**STAFF RECOMMENDATION**

**1516 Ordway Place**

**June 21, 2017**

**Application:** New construction—infill

# SITE PLAN

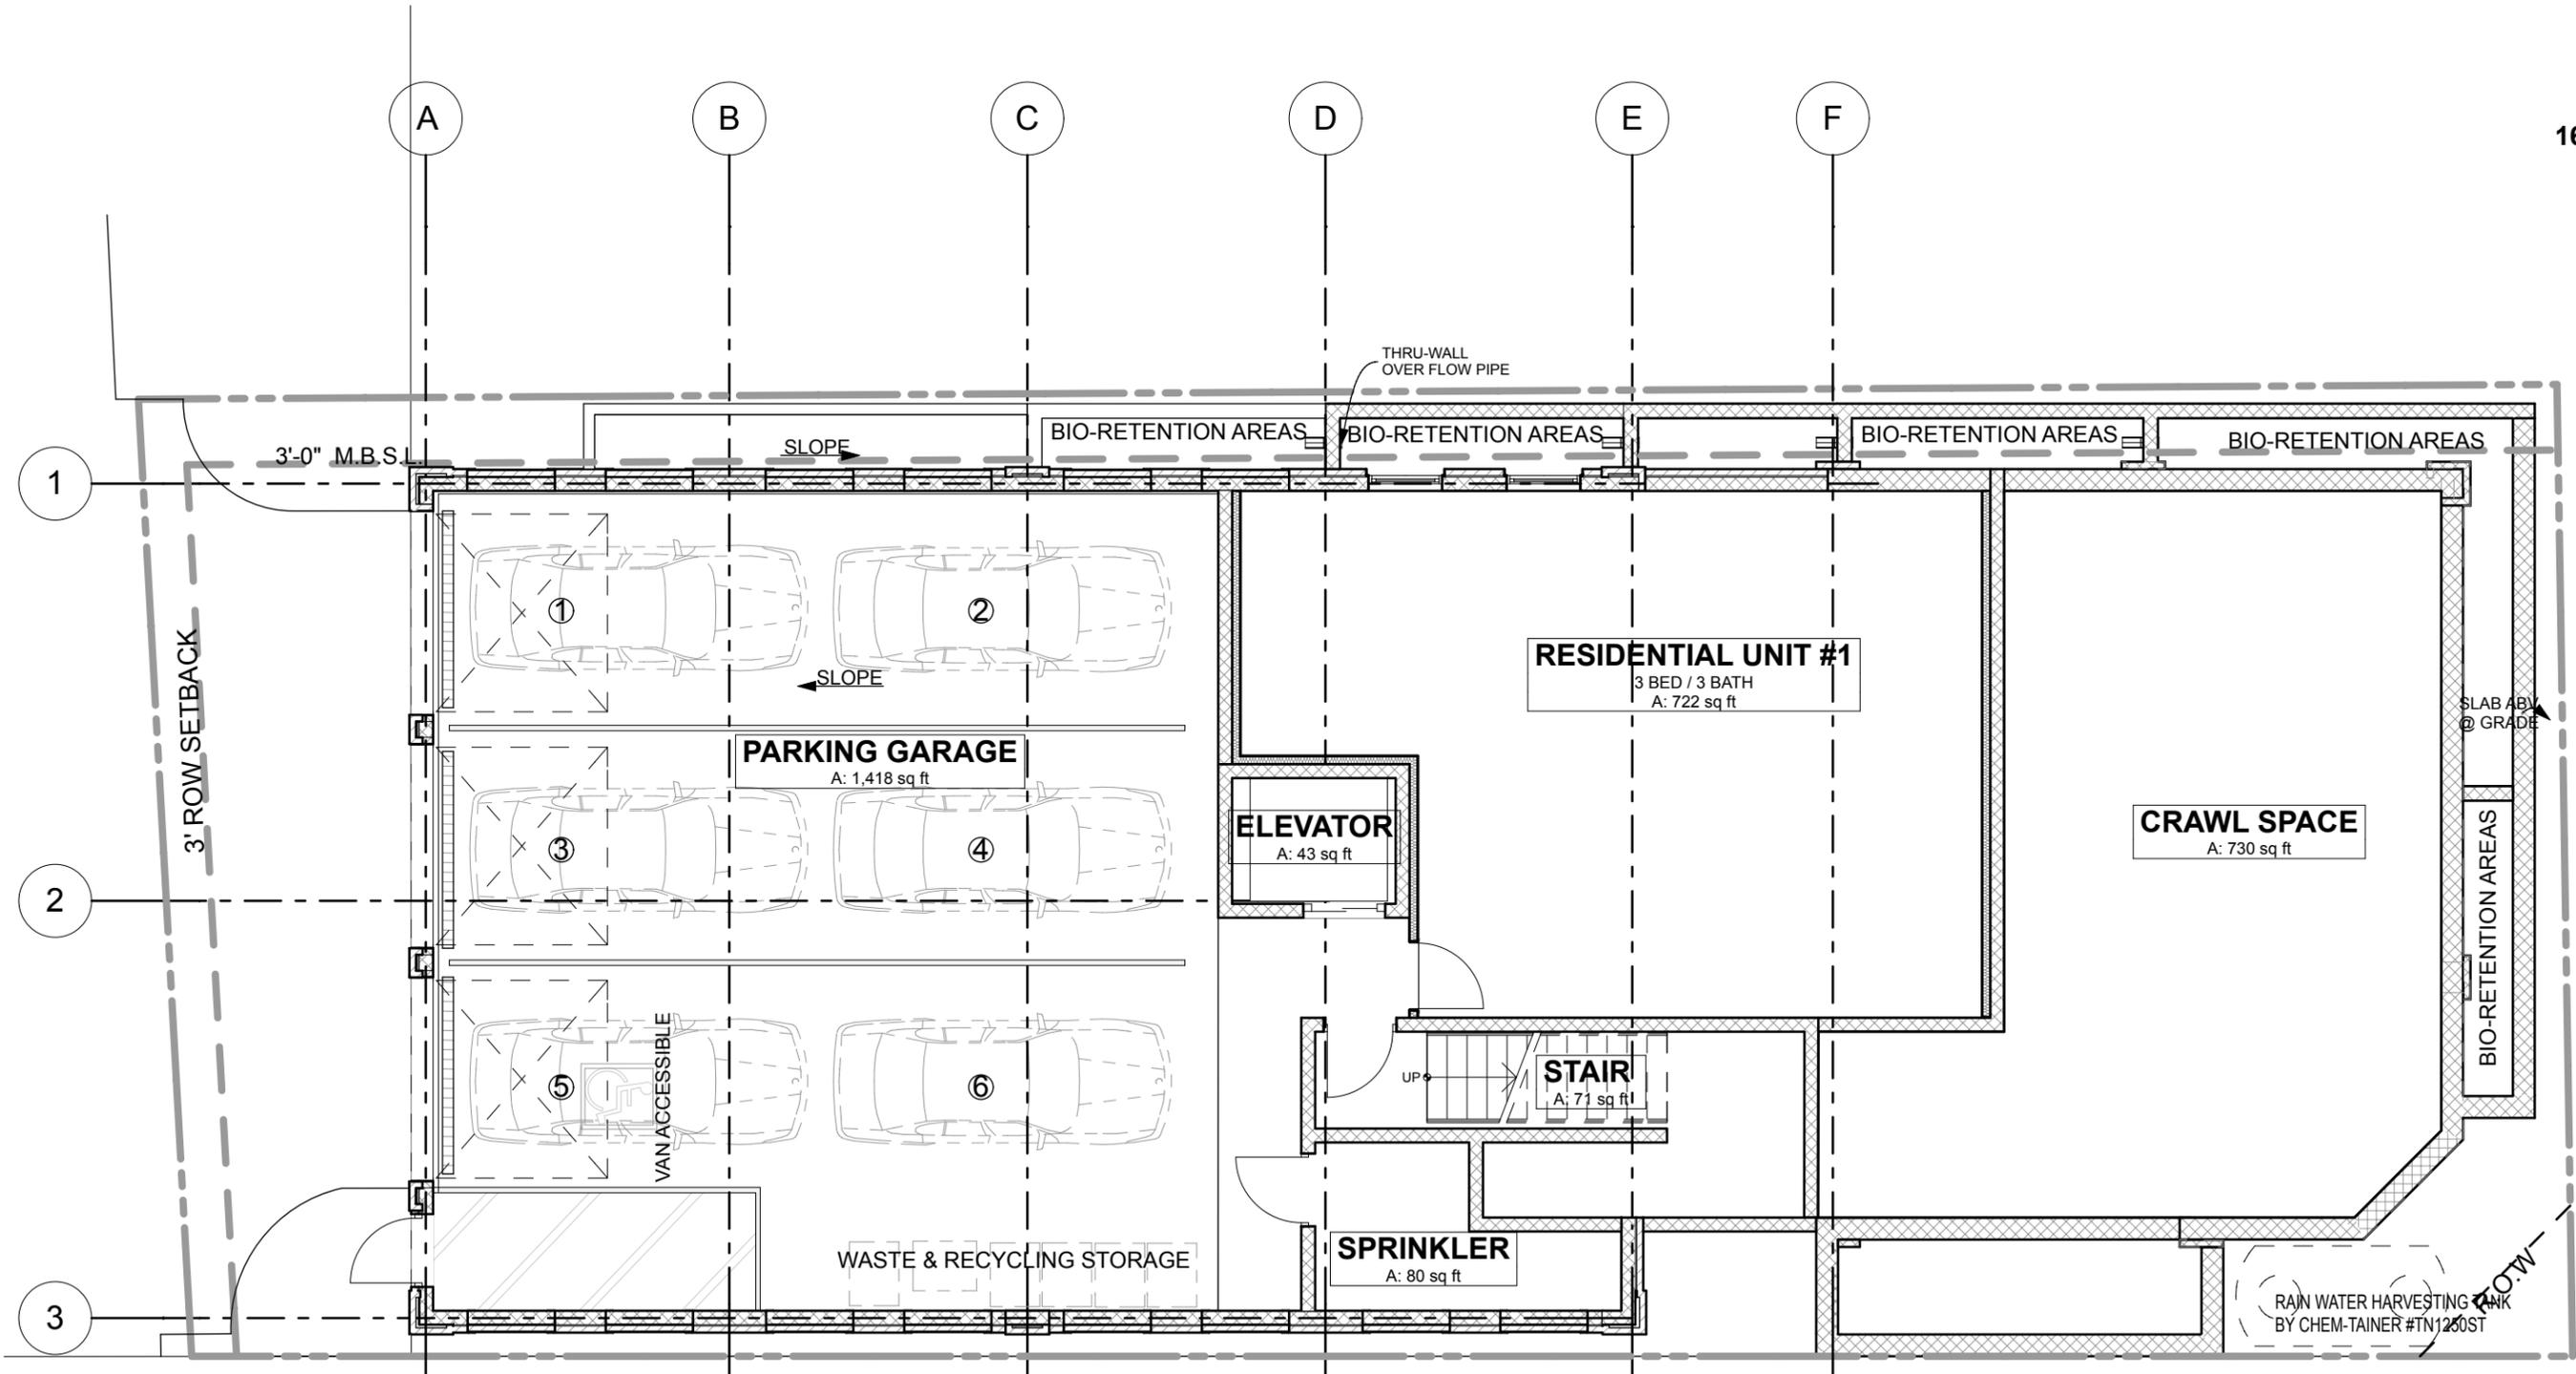
Setback & Rhythm of Spacing: The proposed setbacks are the same as what MHZC approved in 2009. The infill will be approximately four feet (4') back from the sidewalk line along Ordway Place. Along 16<sup>th</sup> Street, the portion of the infill closest to Ordway Place will be five feet (5') from the sidewalk line, and the rear portion of the infill will be one foot (1') from the sidewalk line. The infill will be approximately three feet (3') from the right/west side property line. The rear property line angles so that the infill sits between ten and twelve feet (10'-12') from the rear property line. Staff finds these

proposed setbacks to be appropriate for a commercial structure on a commercial corner, and finds that the project meets Section II.B.3. of the design guidelines.

**1 PROPOSED NORTH ELEVATION**  
SCALE: 1/8" = 1'-0"

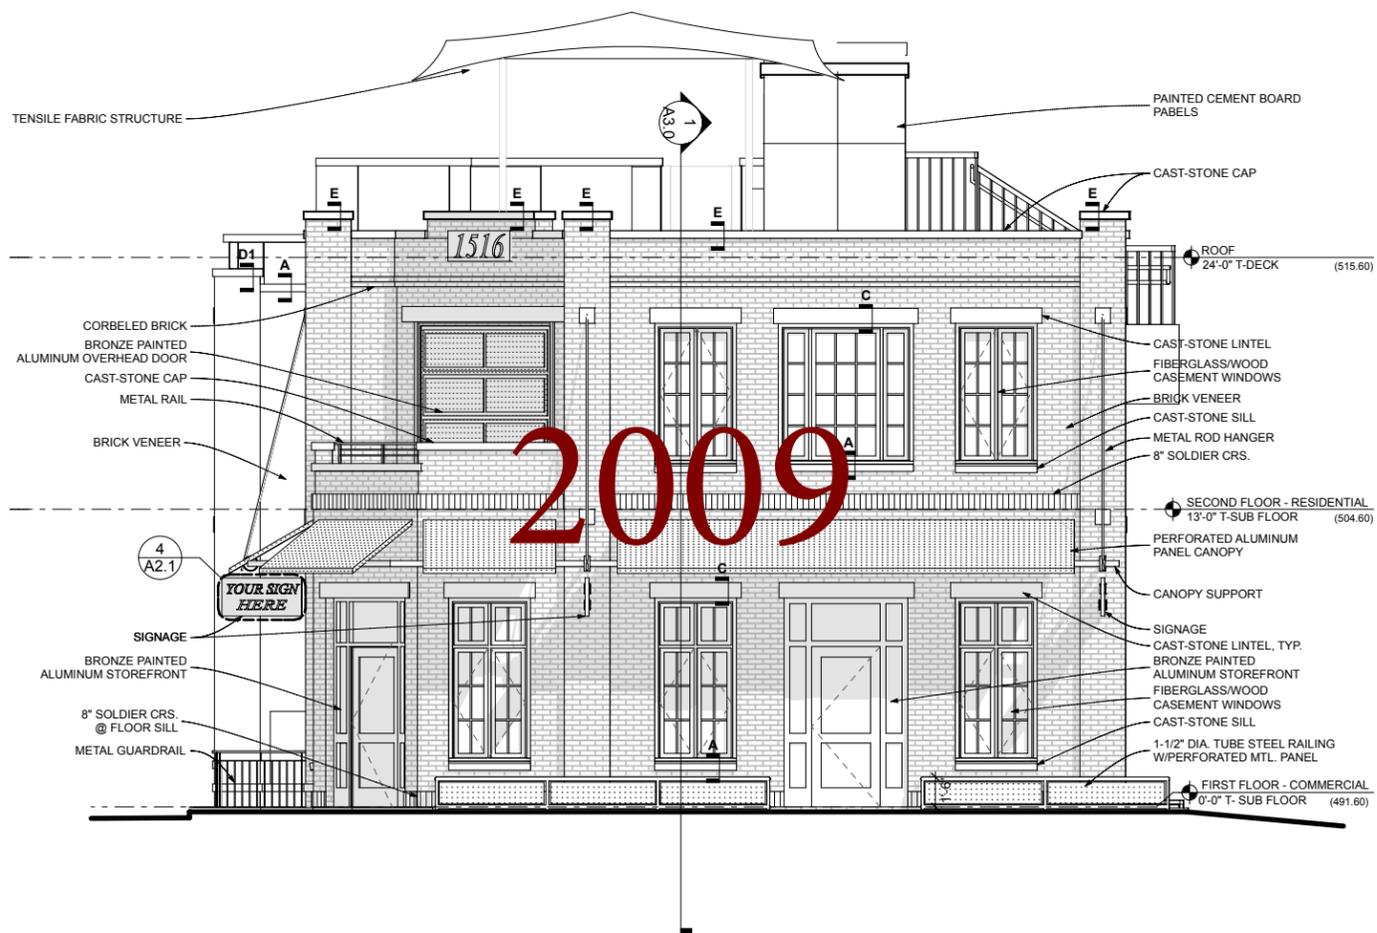
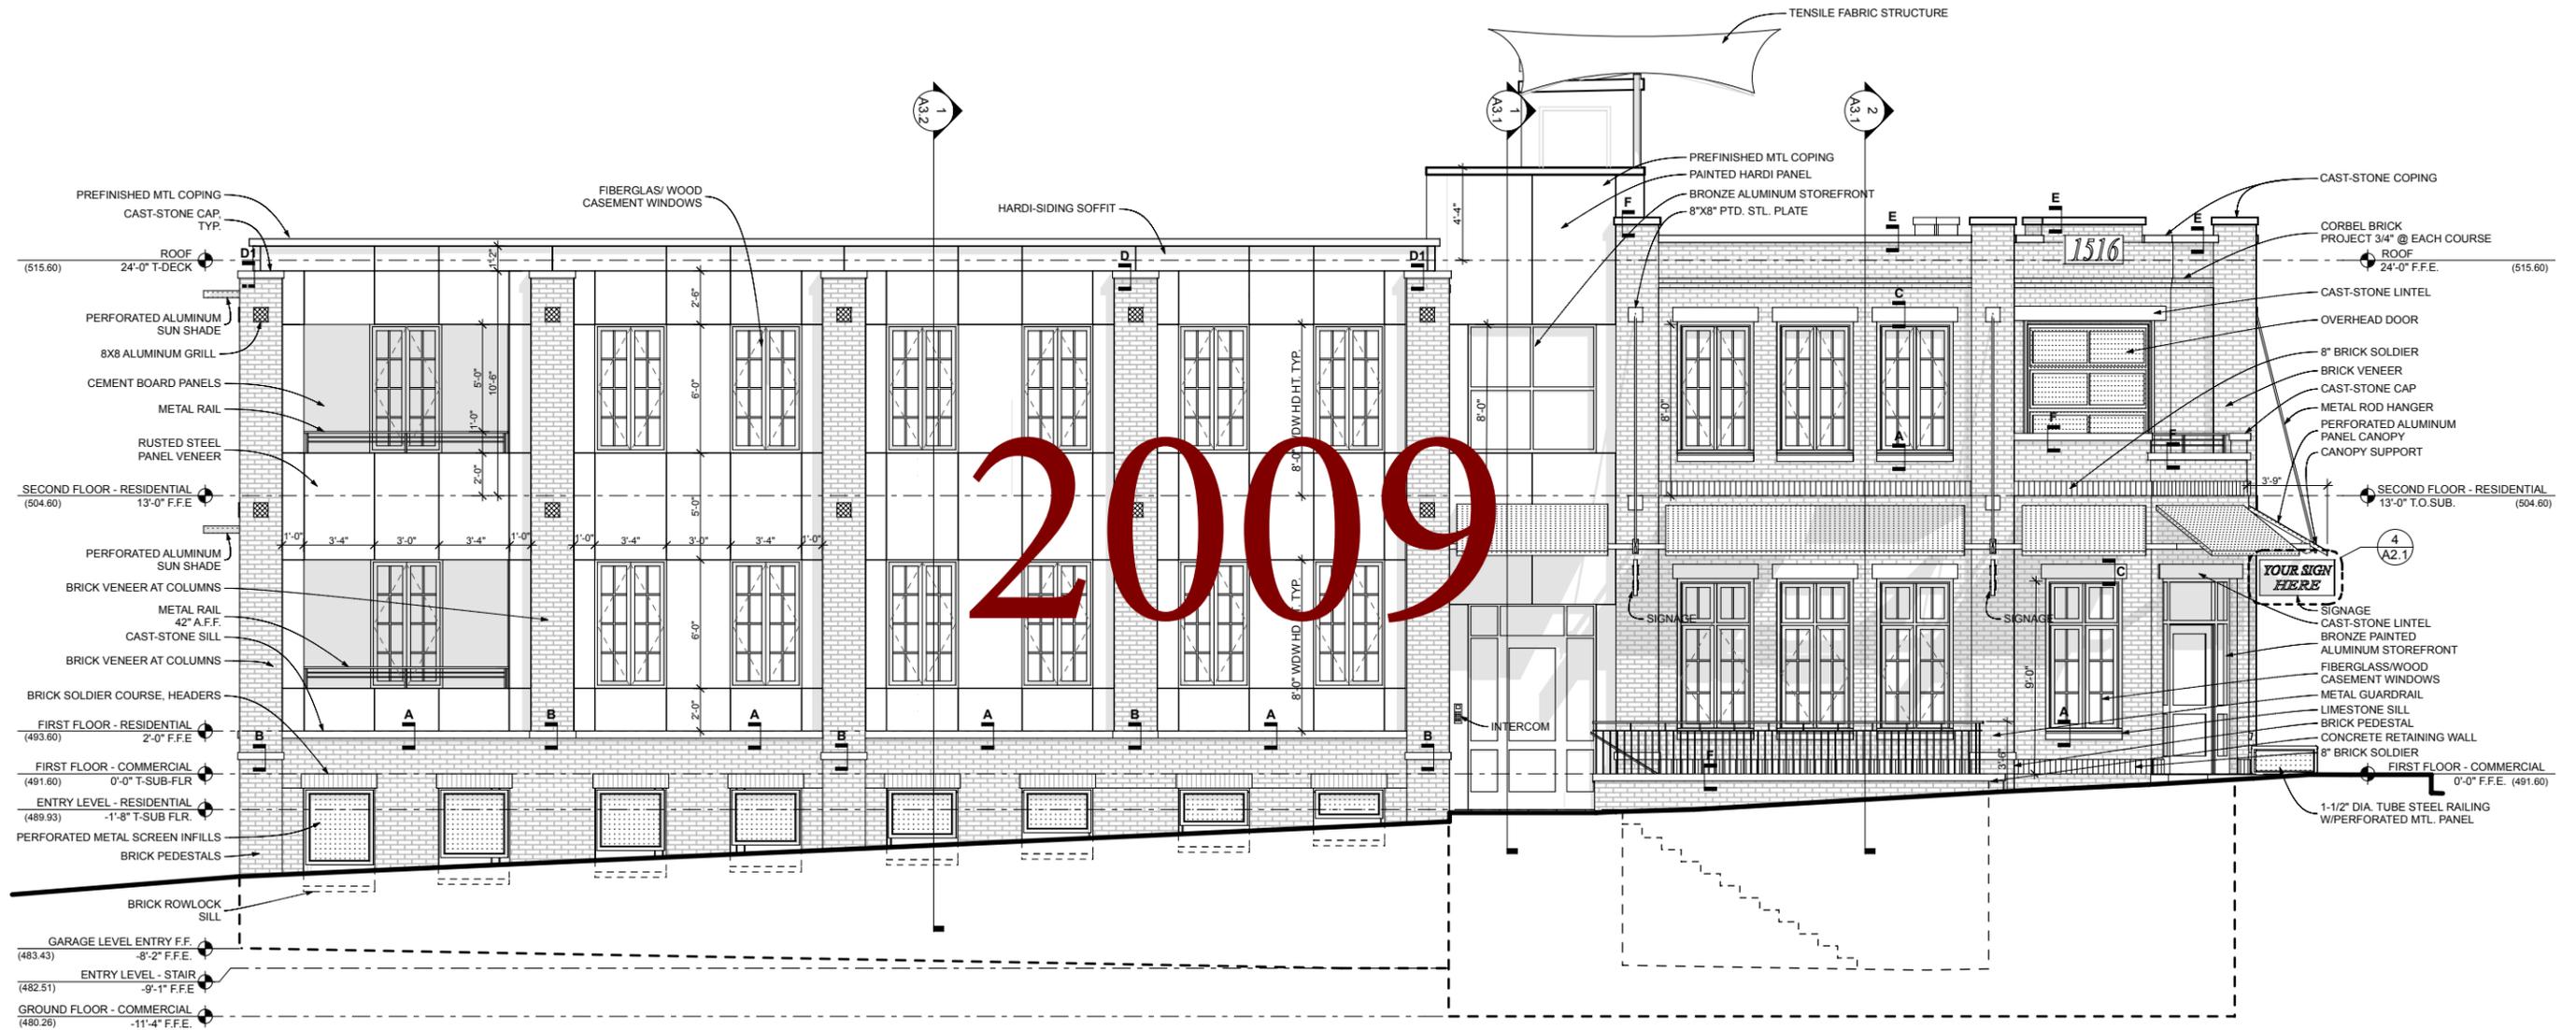
# ELEVATION MODIFICATIONS:

1. CHANGED STOREFRONT DOOR TO WINDOW.
2. CHANGED CAST-STONE CAP TO PRE-FINISHED METAL COPING AT PARAPET.
3. CHANGED SECOND FLOOR GARAGE DOOR TO STOREFRONT DOOR.

**1** PROPOSED EAST ELEVATION  
SCALE: 1/8" = 1'-0"

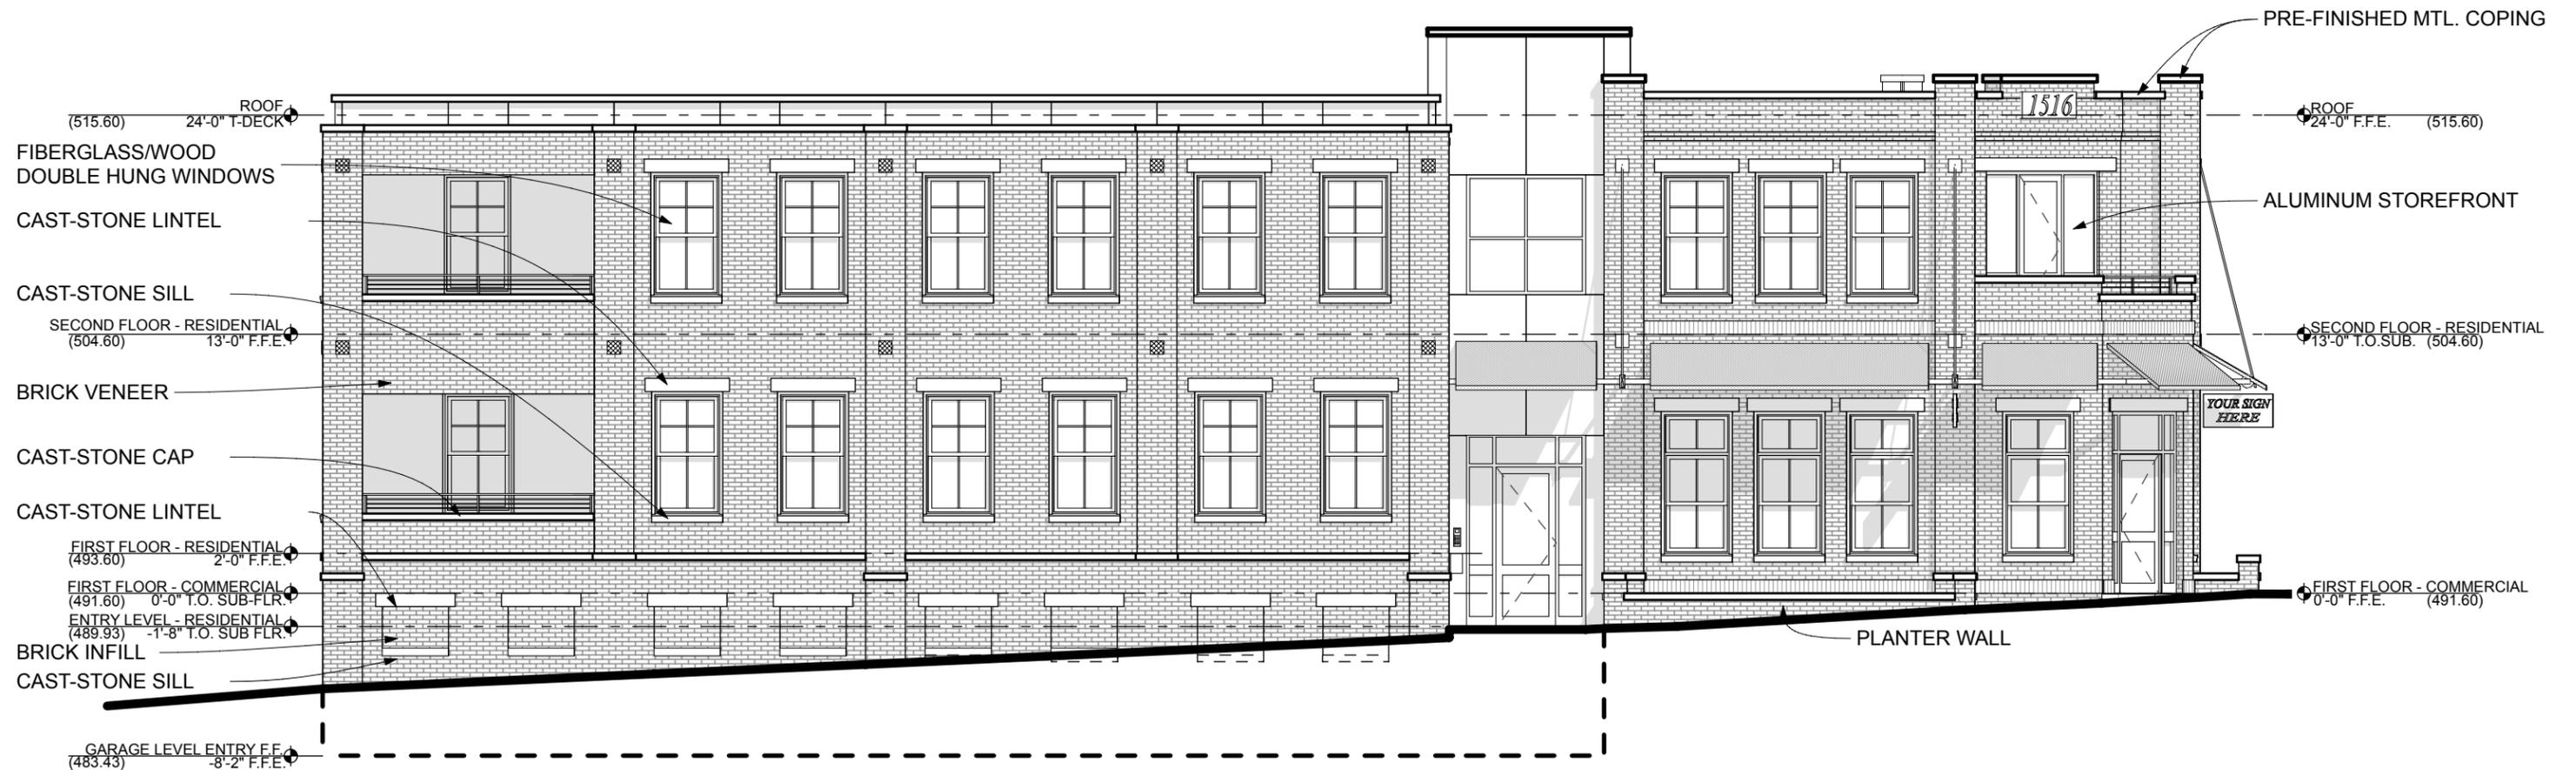
# ELEVATION MODIFICATIONS:

1. CHANGED SECOND FLOOR GARAGE DOOR TO STOREFRONT DOOR.
2. CHANGED CAST-STONE CAP TO PRE-FINISHED METAL COPING AT PARAPET.
3. CHANGED RUSTED STEEL PANEL VENEER TO BRICK VENEER.
4. CHANGED OPEN AIR GARAGE PERFORATED SCREENS TO BRICK INFILL.
